**REVISION 005 TO AN INVITATION TO TENDER**

<b>Title:</b> Construct an Energy Efficient Duplex in Pond Inlet	
<b>Solicitation No.:</b> 5P468-22-0003/A	<b>Date:</b> September 14, 2022
<b>Amendment No.:</b> 005	
<b>Client Reference No.:</b> N/A	
<b>GETS Reference No.:</b> PW-22-00999981

## Amendment 005

This amendment is raised to extend the solicitation closing date and to answer questions from bidders.

**Q8. REF SPECIFICATION 05 73 00 DECORATIVE METAL RAILING**

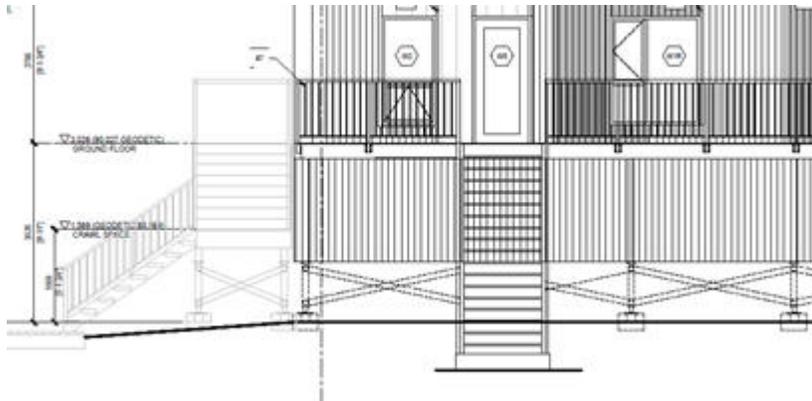
Point 1.1.1.1 states for "Glass panel railing system" but all elevations show a railing with posts and pickets. Please advise

*A8. Revise Glass panel railing system to 'Aluminum' railing system.*

*The remaining of the spec section has all the aluminium railing details and requirements.*
